**Knoxville Marriott Revisions**  
**Meeting Date:** 9/16/2020  
**Applicant:** Kathryn Greer, MHM

Exterior work on the Knoxville Marriott Conversion, including improvements to the World's Fair Park elevation, was reviewed and approved by the DRB on March 20, 2020 (3-A-20-DT). This proposal includes revisions to the previously approved design, including revisions to the World's Fair Park elevation and the coffee shop entry on the west elevation.

**9-A-20-DT**

**Downtown Design COA Application – Knoxville Marriott Conversion Exterior Updates – Public Space**

4 PARTIAL EAST ELEVATION AT NEW CAFE AND ENTRY  
A305.2 3/32" = 1'-0"

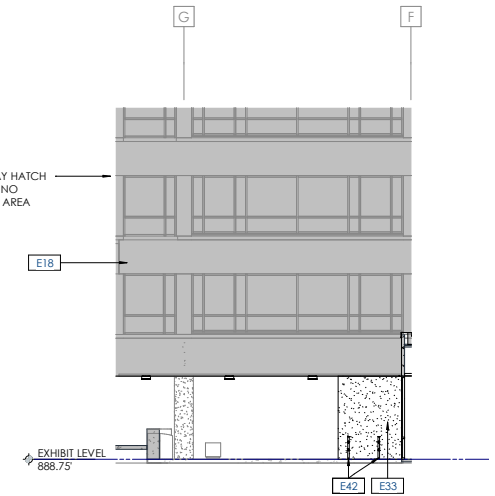
The proposal also includes revisions to the previously-approved windows at the east elevation coffee shop.

2 PARTIAL ELEVATION AT PATIO  
A302.2 3/32" = 1'-0"

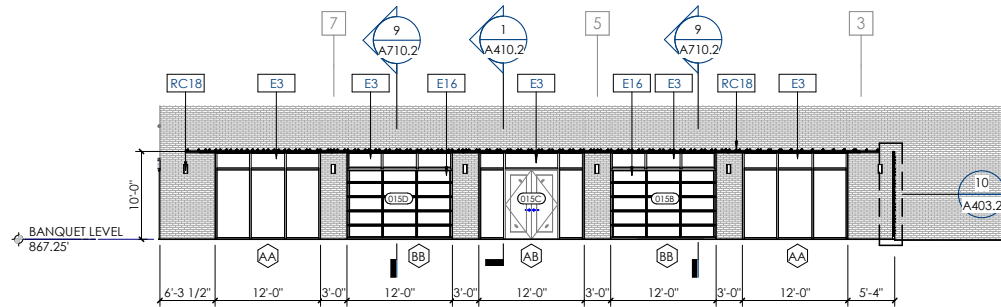
Reviewer Comments: The axon/rendering and sheet A302.2 show what is described as "Alternate 5" on the title page (two garage doors) vs the "base bid" of two storefront systems. The full-color renderings included show different doors than the elevation drawings. Staff or board approval may be required to change the storefront systems to garage doors.

Lindsay Crockett confirmed that board approval will be required for the updates to the World's Fair Park façade at the exterior patio. Additionally, MHM is submitting updates to the coffee shop exterior windows.

# WORLD'S FAIR PARK ENTRY - UPDATED WITH PATIO OVERHEAD DOORS

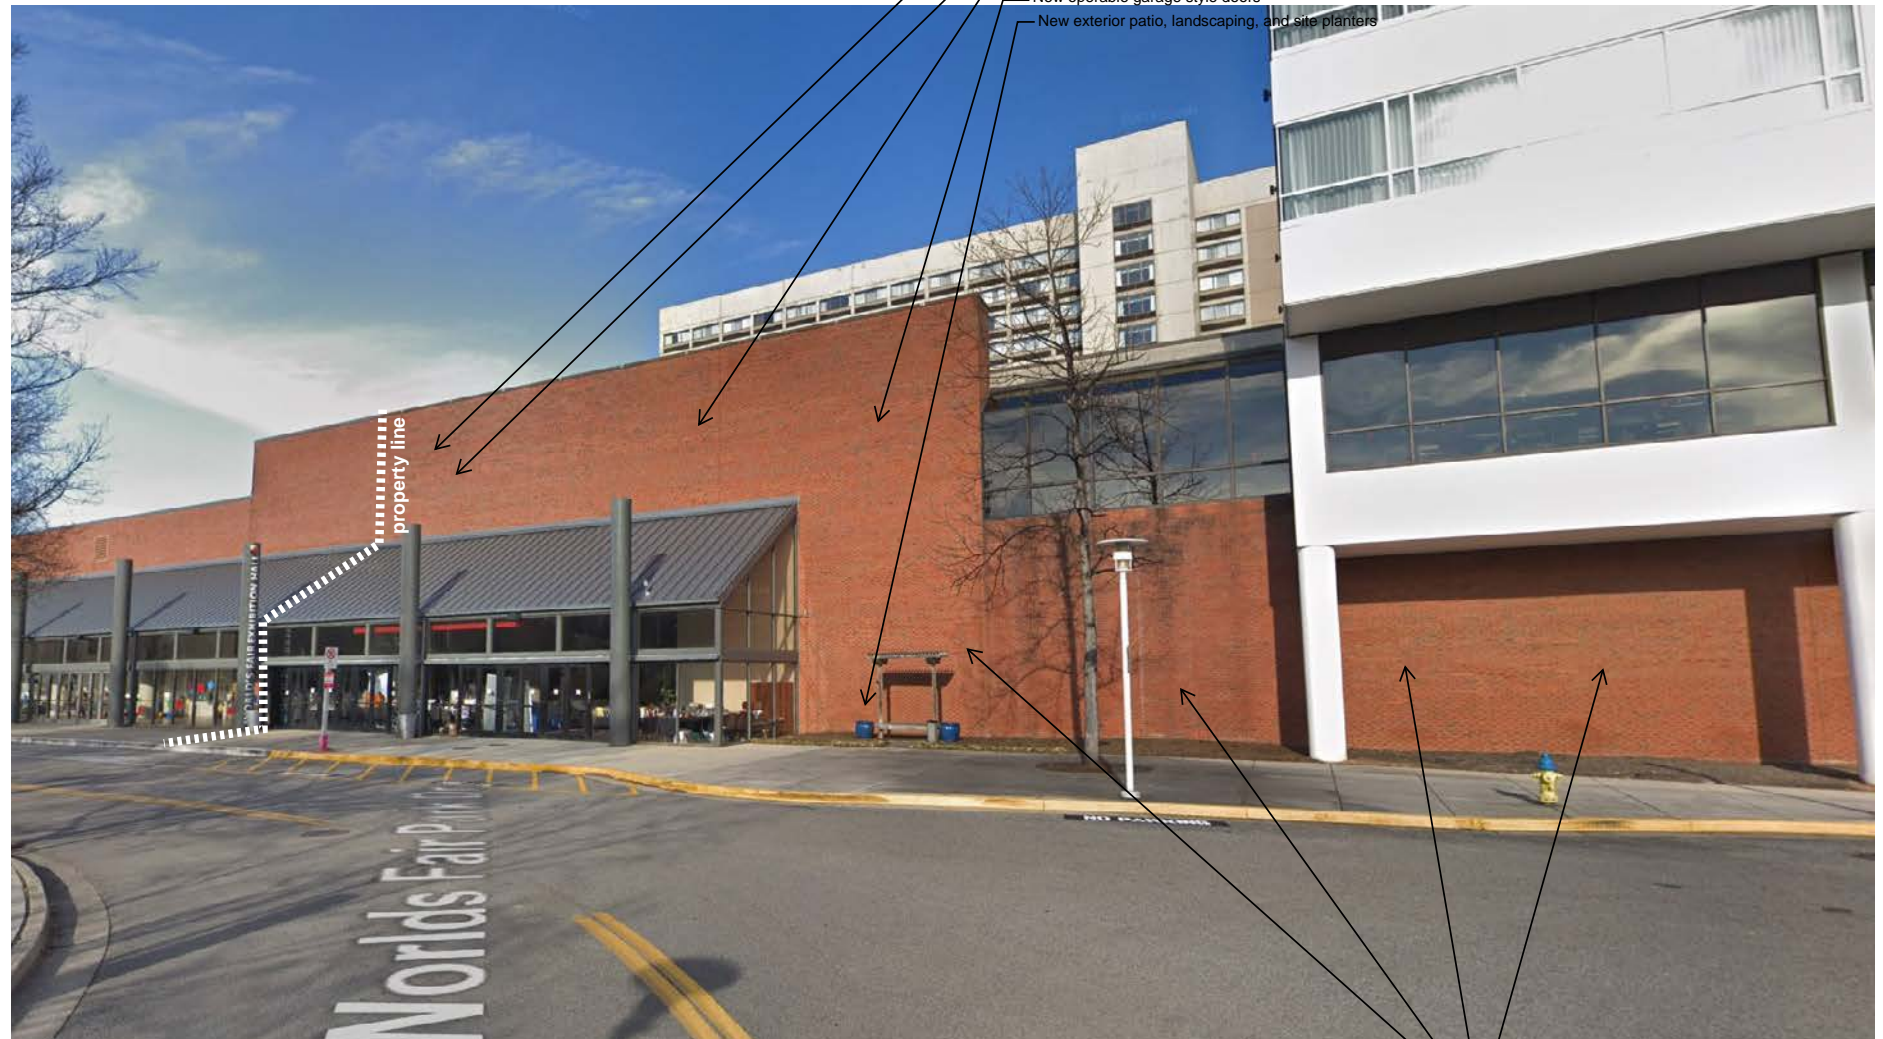
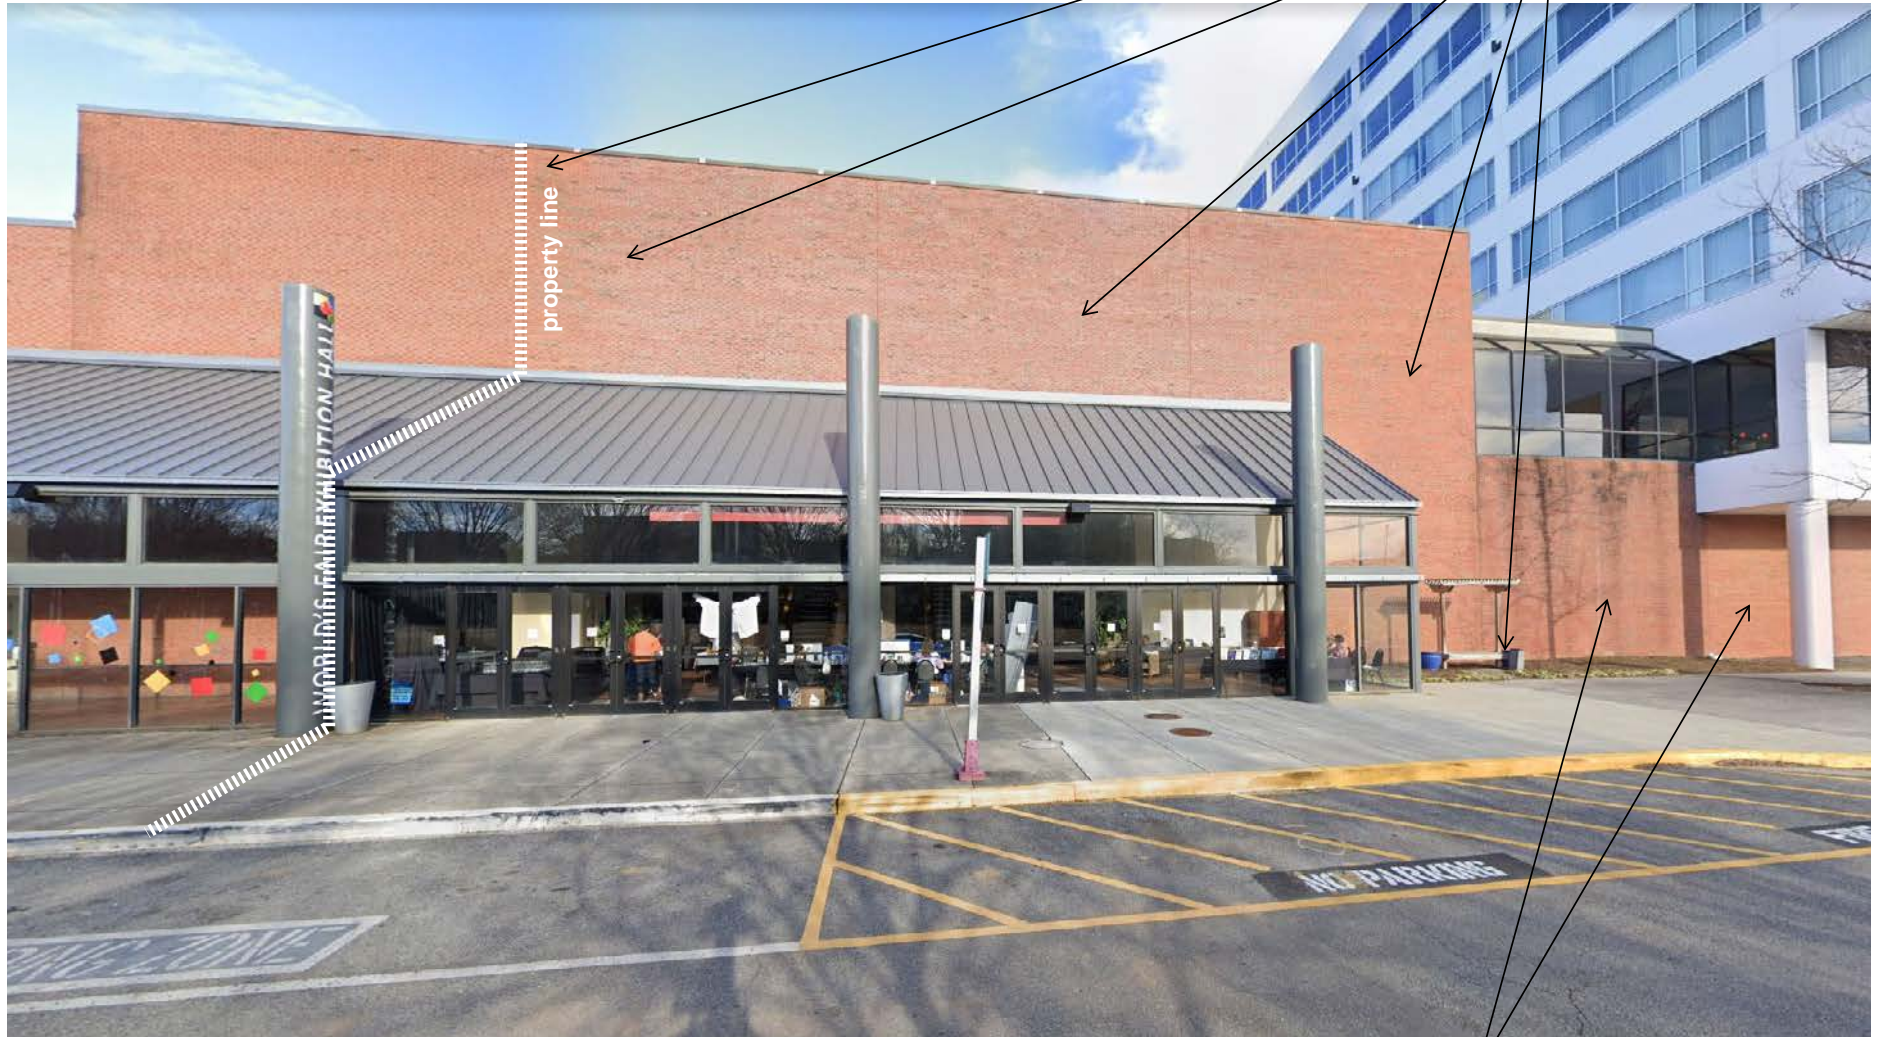
The World's Fair Park elevation will receive new punched opening windows and new operable garage-style doors at the restaurant (upper) level and the exterior patio (first story). Renderings also show two options for the exterior brick façade, which will be painted to the property line. Upon further review with the City of Knoxville and the property owner, the proposed paint may extend to the end of the parapet.
